Parts change announcement

- Change on how to attach the replaceable tongue part

MW13/14/16 Difficult Airway Management Simulator Series

Change on how to attach the replaceable tongue part

The pin attached to the lower jaw

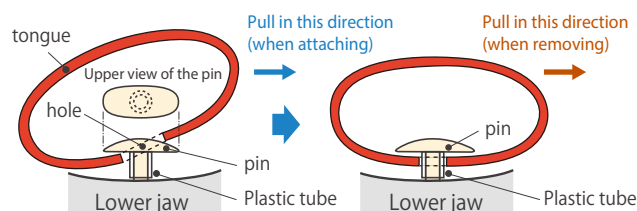
Previously, the anchor pin to connect the tip of tongue and the lower jaw was attached to the tongue side (11392-030). Now the design of the parts has changed so that the pin is fixed to the jaw side (11392-080). This improvement permits longer life of the tongue.

Previous model user needs the pin that is fixed to the jaw. Accordingly, one (1) pin is included in this parts set.

Hook one side of the pin's head through the hole at the tip of the tongue. Then pull the tongue in the opposite direction to expand the hole. Once the hole is large enough, fit the pin through the hole to secure the tongue in place. To remove, pull the tongue to one side to expand the hole and remove from the pin.

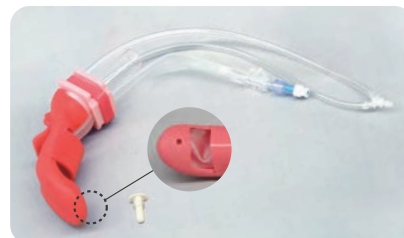
Previously, the anchor pin to connect the tip of tongue and the lower jaw was attached to the tongue side (11392-030). Now the design of the parts has changed so that the pin is fixed to the jaw side (11392-080). This improvement permits longer life of the tongue. Previous model user needs the pin that is fixed to the jaw. Accordingly, one (1) pin is included in this parts set.

[Replacement of the tongue part]

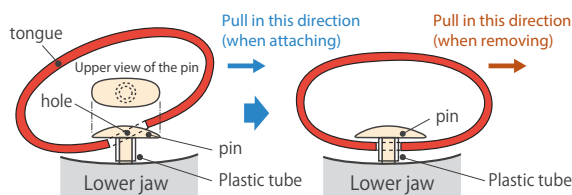
As of May 2015, the design of the tongue parts and its assembly method has also been changed. In case you are installing a new type tongue (11392-080) for the first time to the existing system, the anchor pin need to be fixed to the lower jaw. Follow the instruction below.

2. Insert the anchor pin into the hole and push it firmly until the plastic tube on the leg of the pin touches the lower jaw. Ensure that the long axis of the head of the pin is oriented transversally as shown in the photo.

3. Put the new tongue part into the mouth following the instruction manual. Then hook one side of the hole on the tongue to the edge of the pin and pull the tongue in the opposite direction to expand the hole. Once the hole is large enough, fit the pin through the hole to secure the tongue in place. To remove, pull the tongue to one side to expand the hole and remove from the pin.
